N1092A-04

Modification Available Performance Enhancement Service Note

N1092A DCA-M Sampling Oscilloscope

An improved extinction ratio calibration is available for DCA-M Sampling Oscilloscopes with option 30A or N28

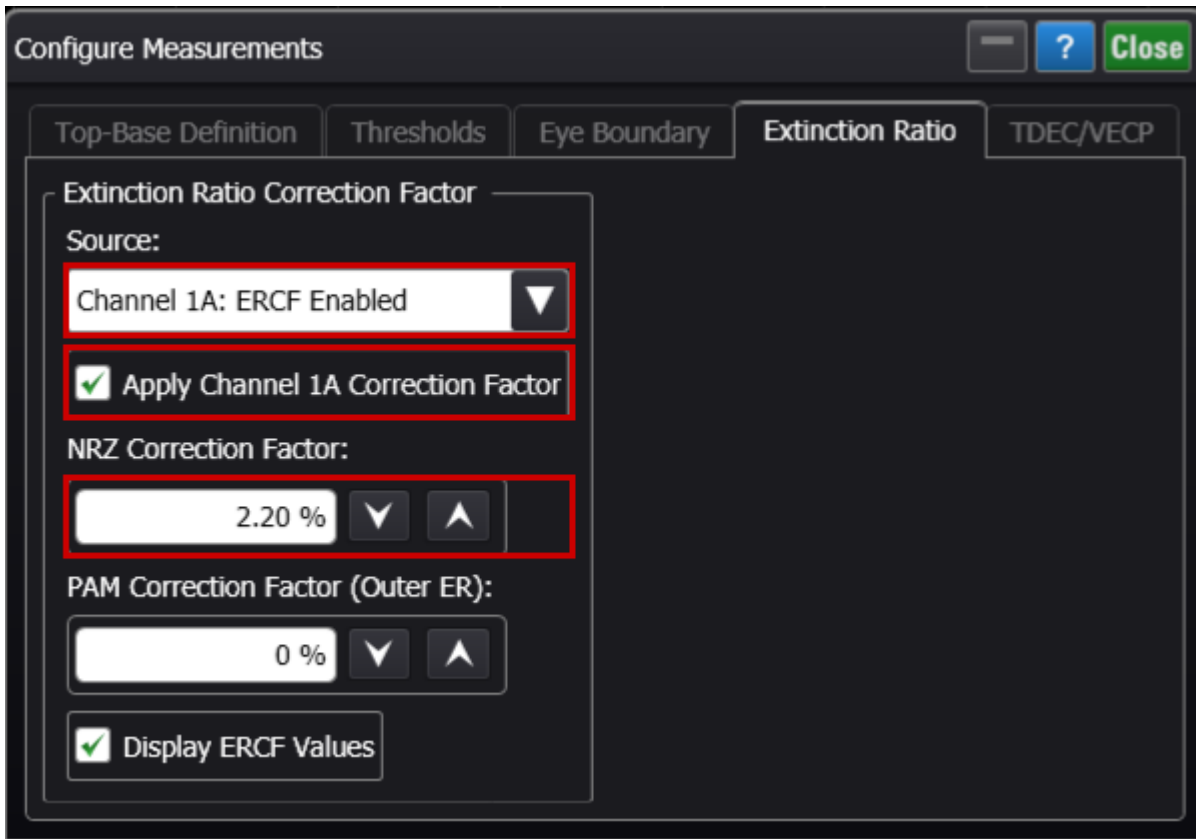
For N1092x DCA-M instruments with option 30A or option N28, units with the improved ER calibration are identified in the Help > About dialog with a “C1” annotation following the serial number.

- If the “C1” annotation is present, the unit has the improved ER calibration
- If the “C1” annotation is not present, the unit has the older ER calibration
